Chapter 2 –Puyallup River Crossing Design Changes

This chapter describes the previously proposed Puyallup River crossing portion of the 167 Extension project, the reasons for changing the design and the proposed new design.

Exhibit 7 – Typical Cross Section of Proposed New SR 167 Southbound Bridge

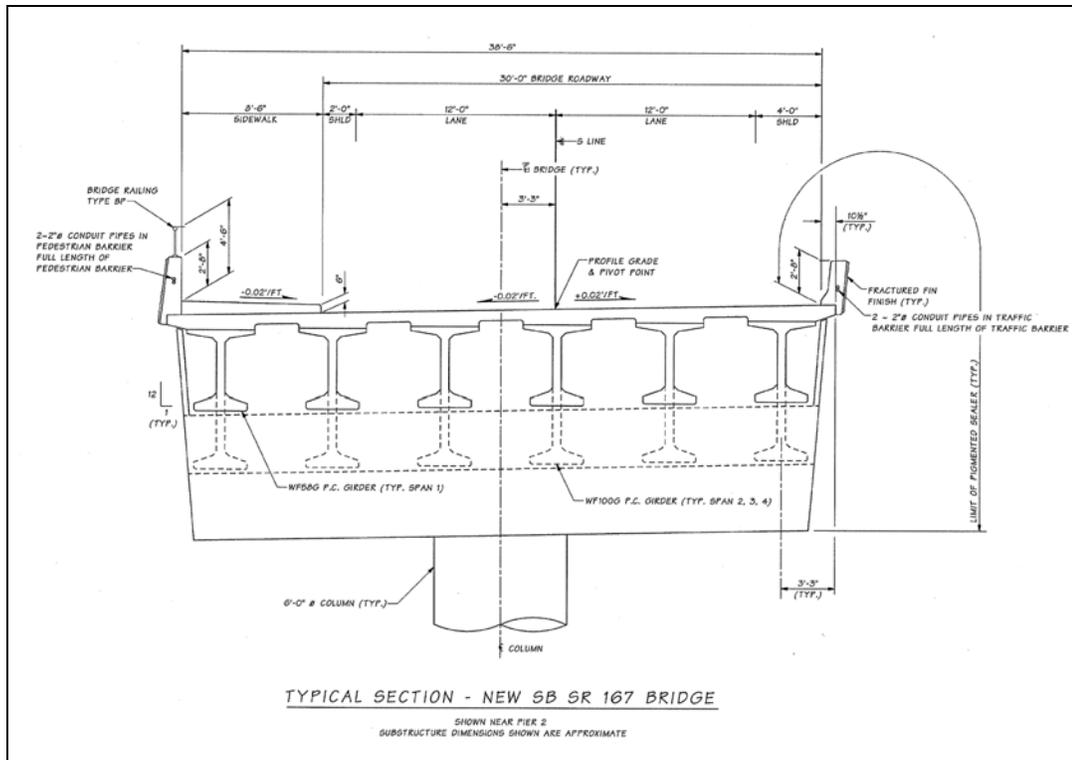
- A temporary in water work trestle, approximately 30' x 100', would be constructed to build one in water pier for the new bridge.
- The new southbound bridge would have two 12-foot wide lanes, a 2-foot wide shoulder and an 8-foot wide sidewalk next to the outside lane, and a 4-foot wide shoulder next to the inside lane. **(See Exhibit 7)**

Exhibit 9 – Cross Section of Proposed 1970 Bridge (modified for northbound lanes)

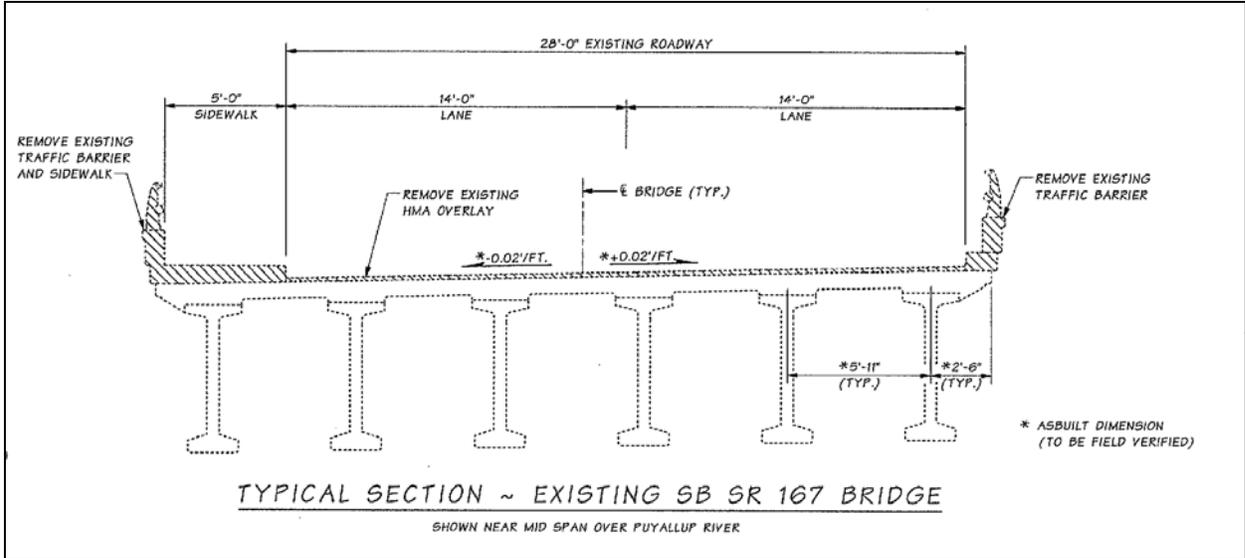
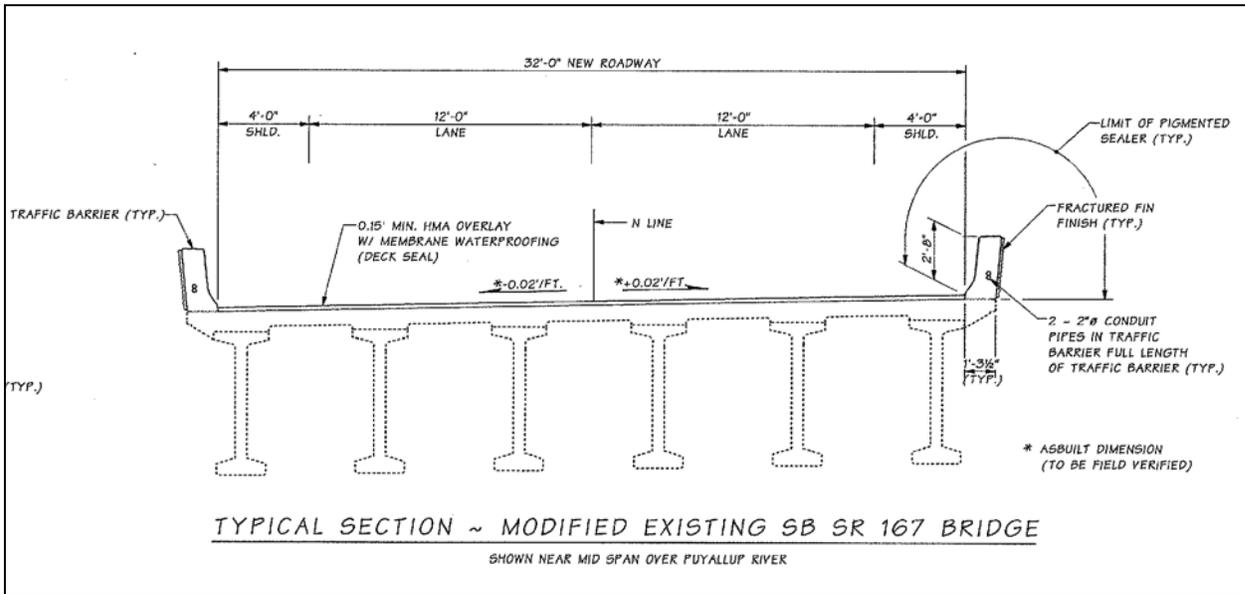
- The 1970 bridge would be modified for interim use for two lanes of northbound traffic, by removing sidewalk, and removing and replacing traffic barriers, and re-striping lanes. **(See Exhibits 8 & 9)**

Exhibit 11 – Proposed Final SR 167 Extension Puyallup River Crossing Alignment

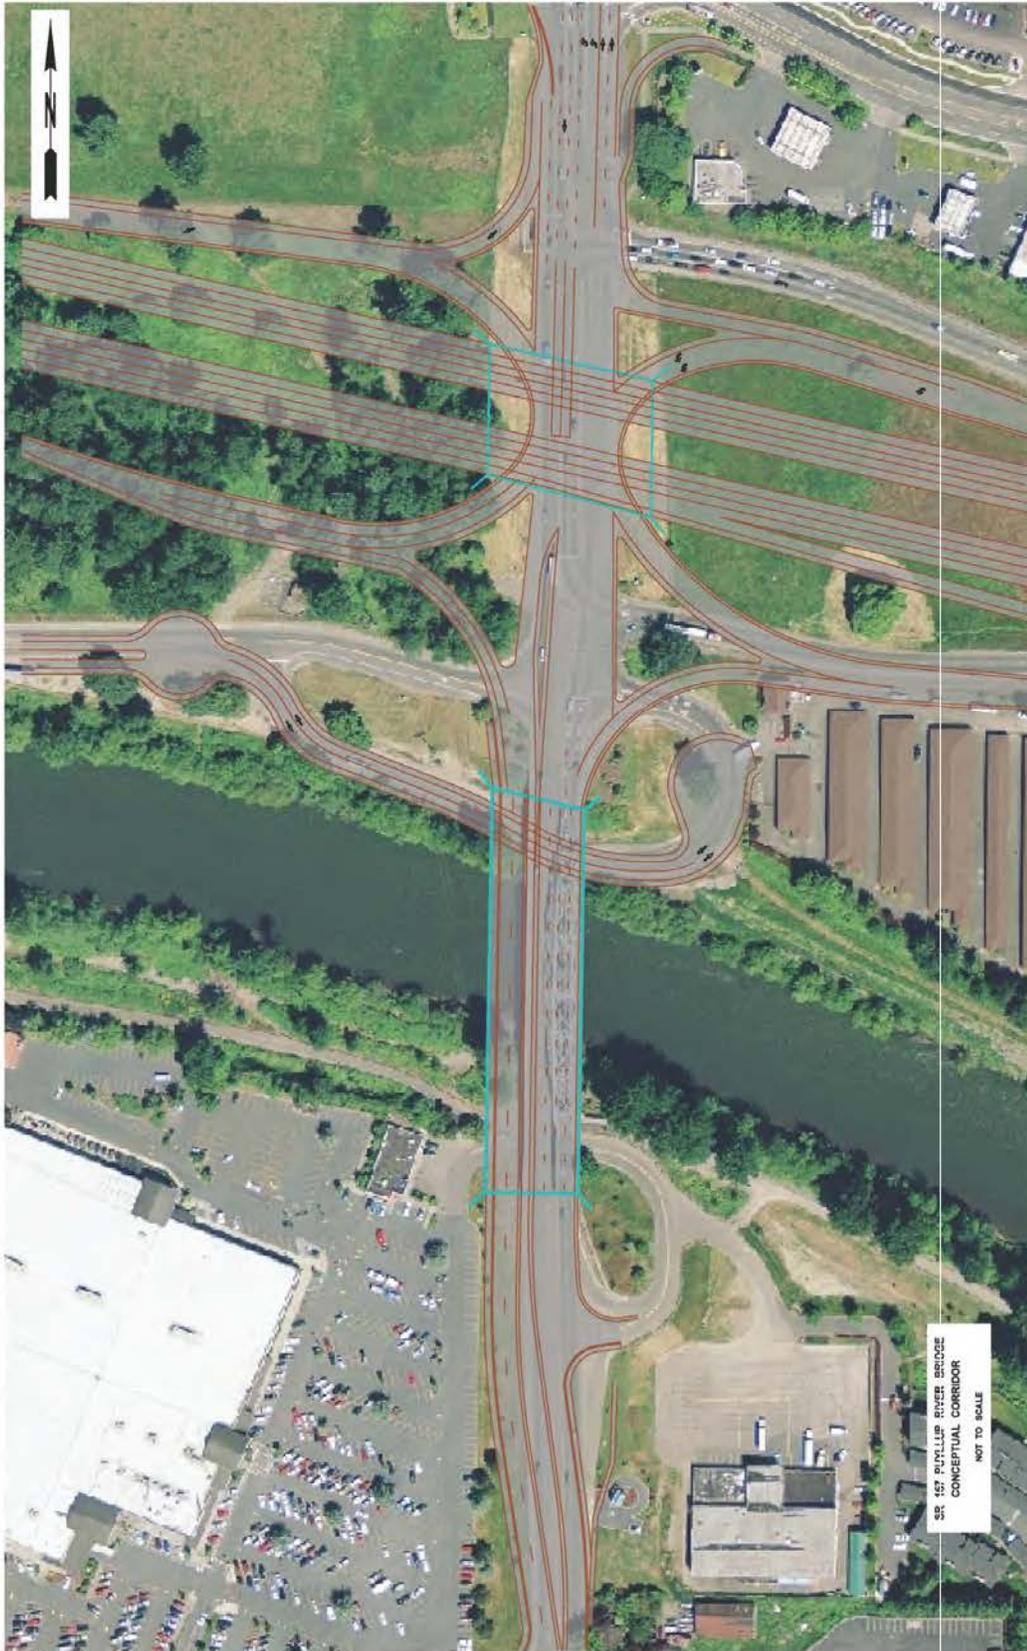
- Traffic would first be reduced to one lane in each direction and shifted onto the new bridge west of the 1970 bridge.
- The 1970 bridge would then be used to stage materials and equipment to construct the first two lanes of the proposed five-lane bridge to the east.

- Once the first two lanes of the five-lane bridge are constructed, materials and equipment would be staged there and the 1970 bridge would then be demolished to make room to finish construction of the remaining three lanes of the five-lane bridge.

Exhibit 11 below illustrates the final alignment of the Puyallup River crossing once the 167 Extension project is completed with future funding.
